ADDENDUM NO. 1

RE: HIGH SCHOOL #13

Howard County Public School System

Bid Number: 016.20.B4

date
 21 JAN 20
dwg
 ADD_1 P21

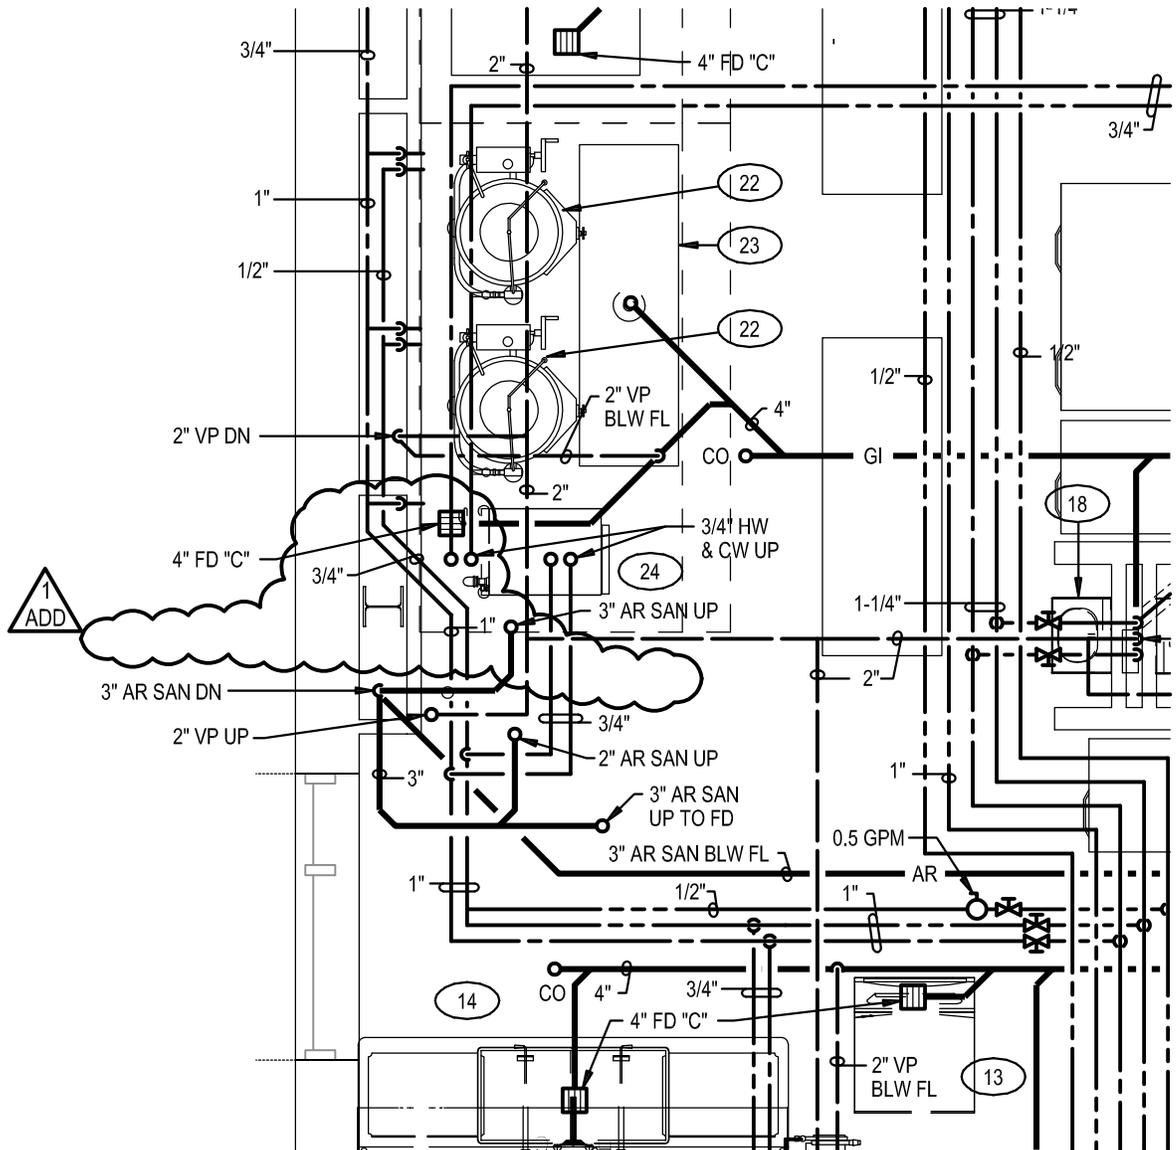
ADD Kitchen equipment 28h per sketch ADD_I_P21.

dwg
ADD_1 P23

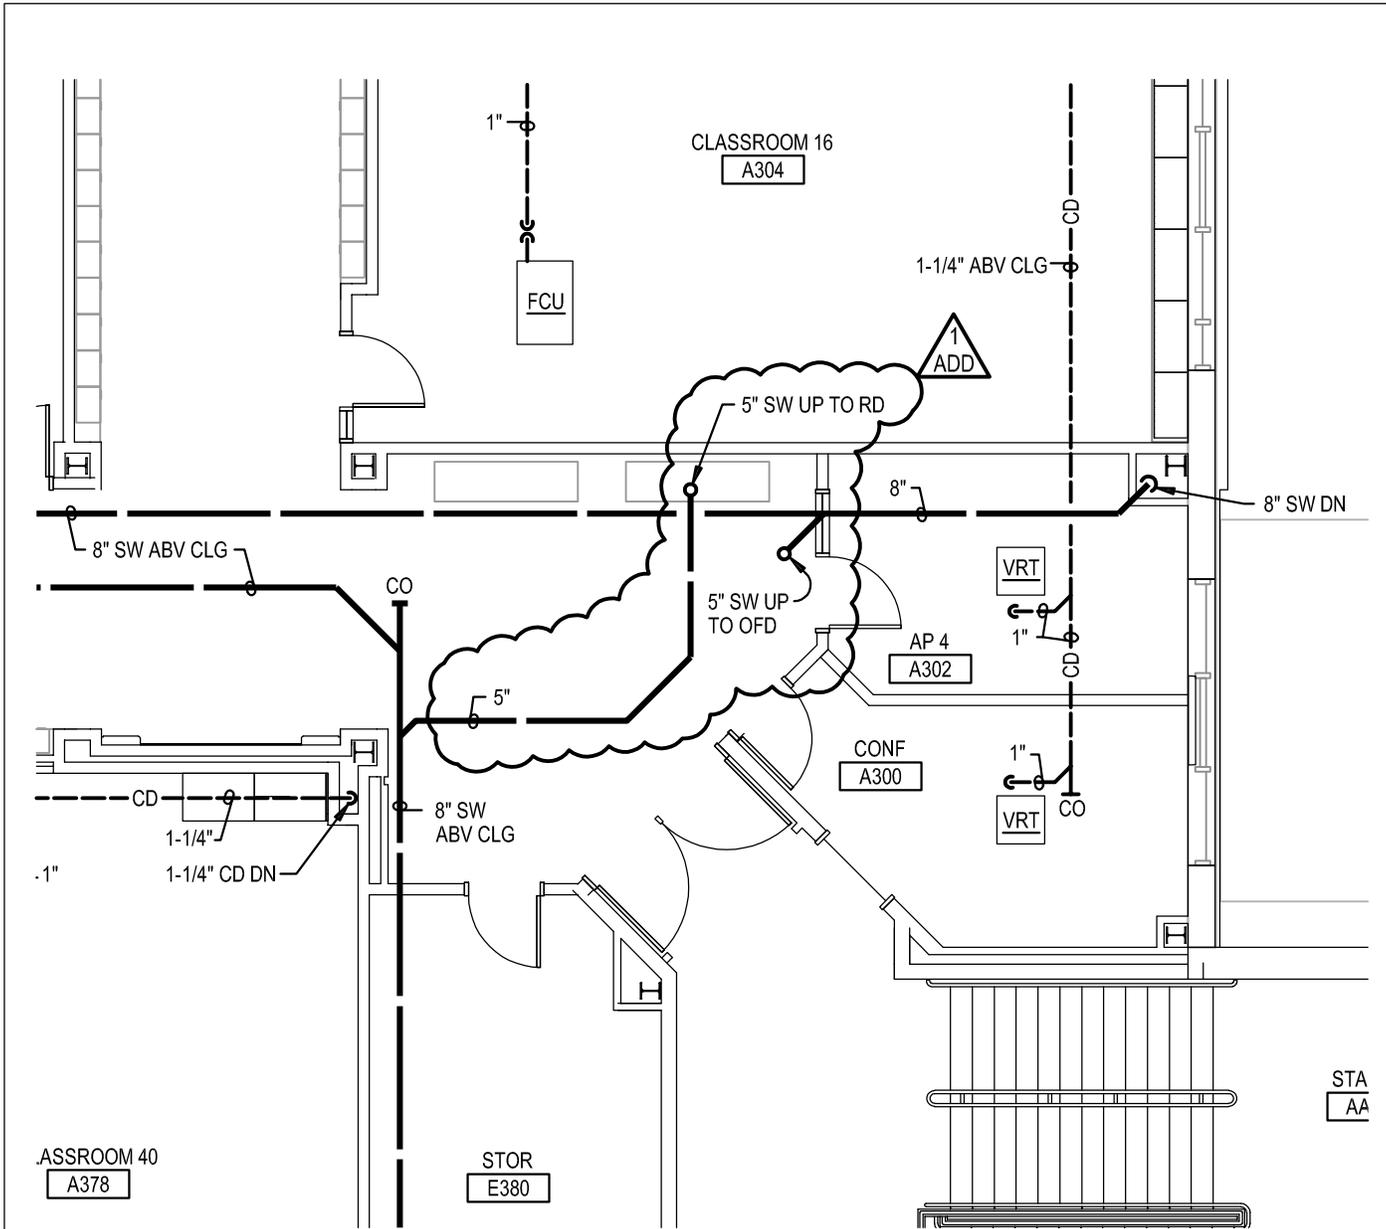
ADD Kitchen equipment 28h to schedule per sketch ADD_I_P23.

dwg
 ADD_1 P24

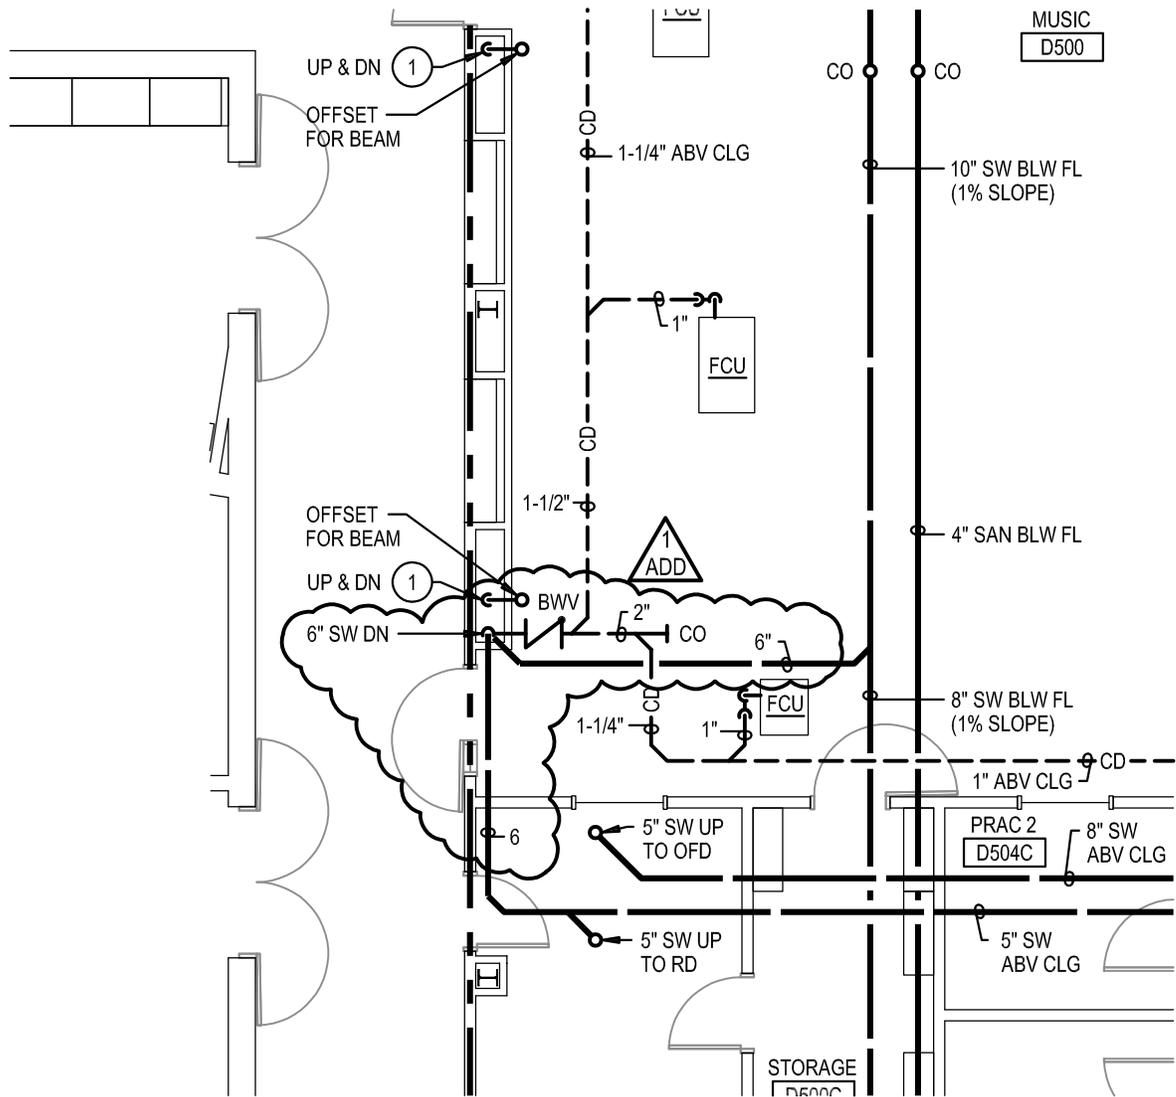
REVISE Pipe size per sketch ADD_I_P24.

dwg
 ADD_1 P25

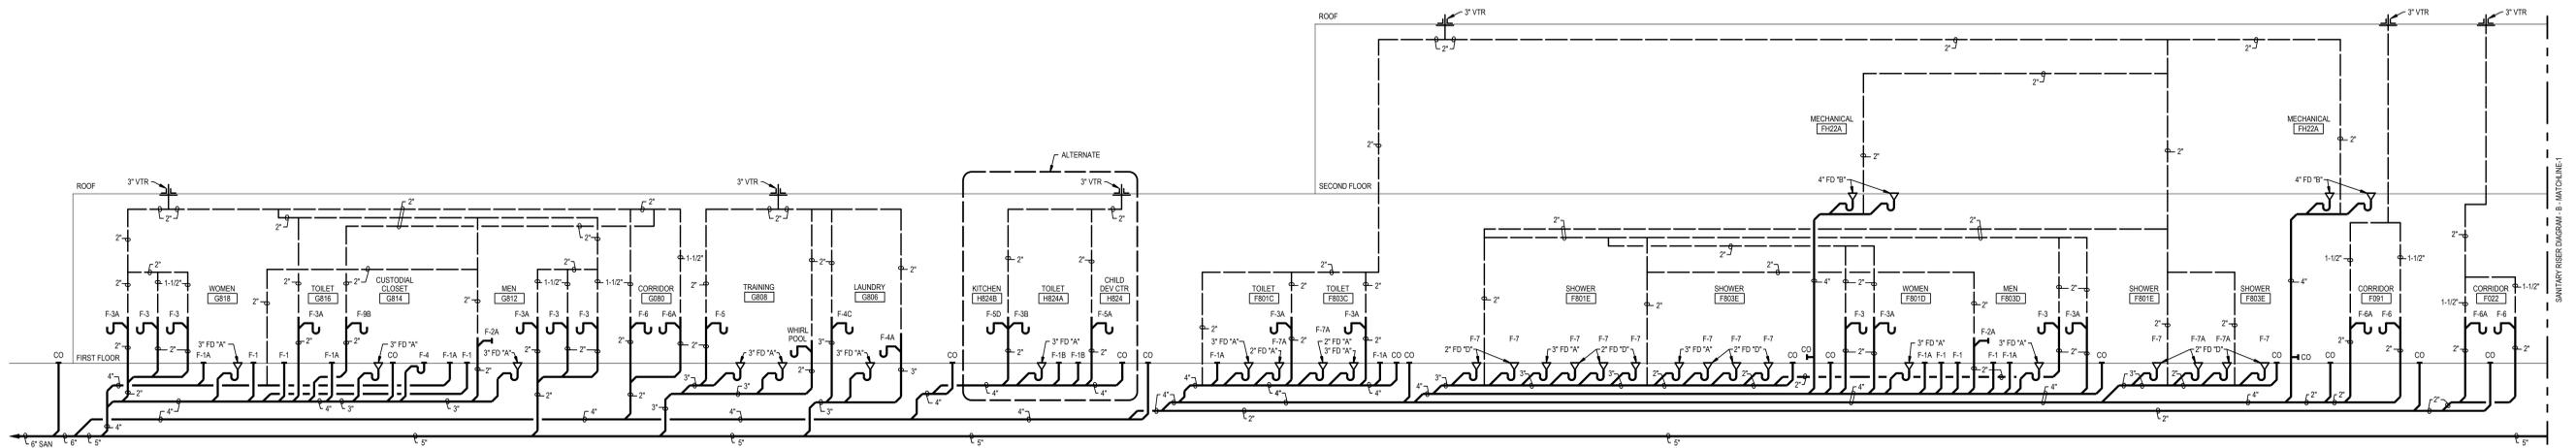
REVISE Pipe sizes per sketch ADD_I_P25.

date 21 JAN 20
dwg ADD_1_E1

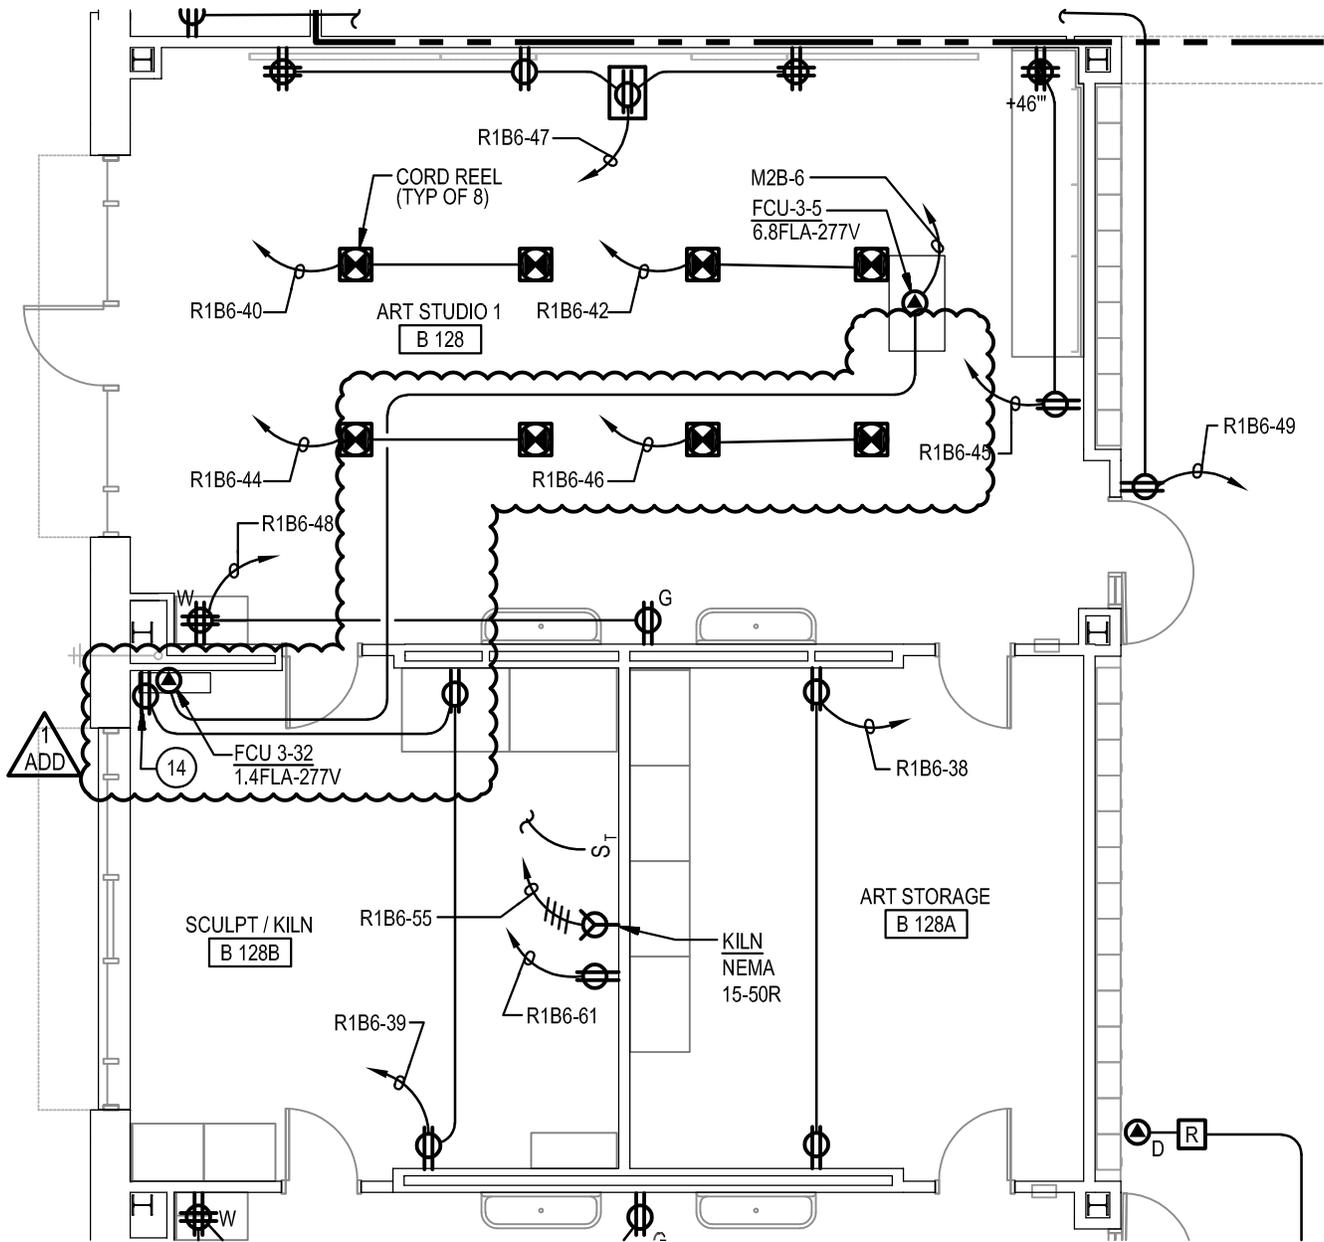
REVISE Breakers and wire size for circuits SL-2,5,14 and 17 in panel SL. Refer to sketch ADD_I_E1

dwg
ADD_1_E2

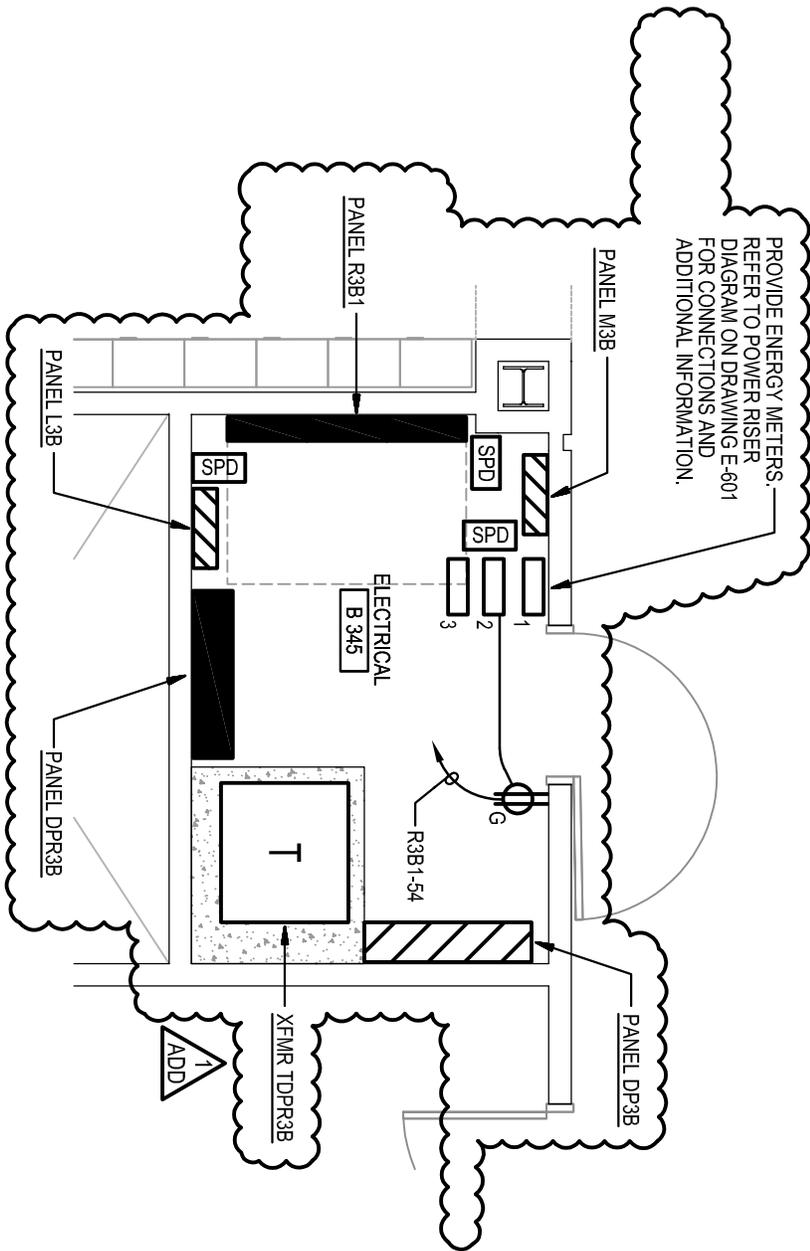
REVISE Cabinet Unit Heater CUH-1-8 in Sculpt/Kiln B128B to FCU-3-32 and connect to FCU-3-5. Refer to sketch ADD_I_E2.

ADD Duplex receptacle in FCU-3-32. Refer to sketch ADD_I_E2.

dwg
 ADD_1_E6

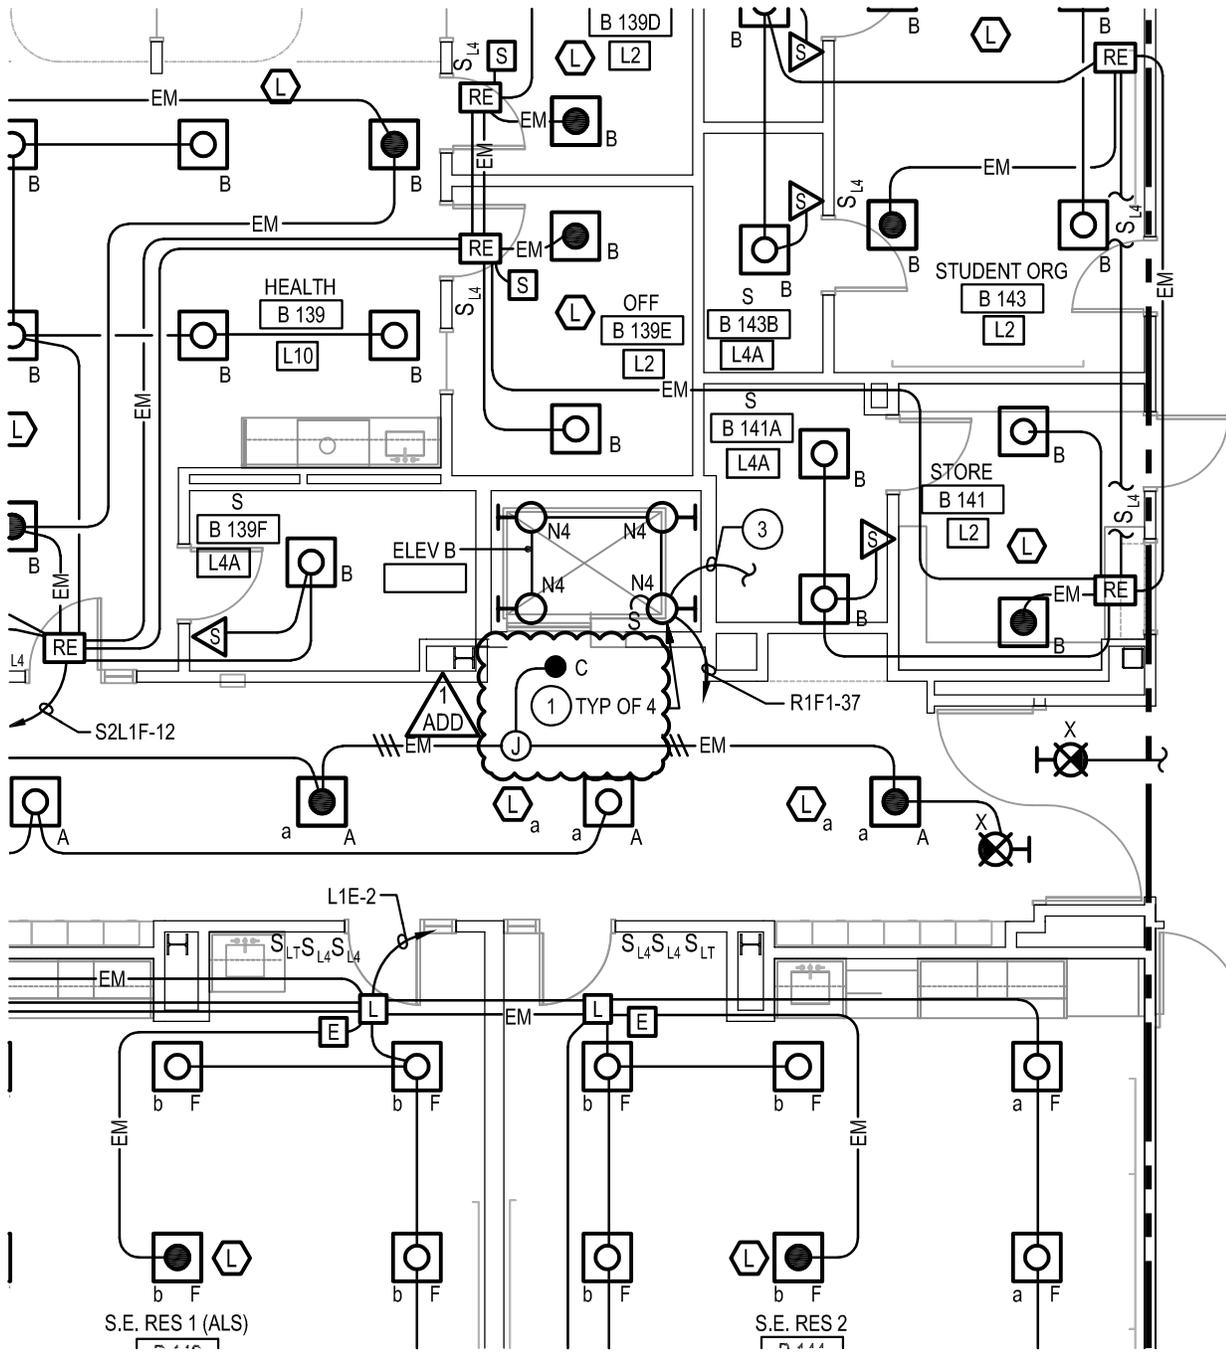
ADD Fixture designation type A to light fixture in corridor A108 outside API A 108A. Refer to sketch ADD_I_E6.

1. Light fixture located in the corridor by room A108A on drawings EL-111 is not labeled.
2. Lighting fixture located in the corridor south of the elevators is labeled as type A on drawing EL-112. This does not match the lighting fixture schedule description on drawing EL-242.
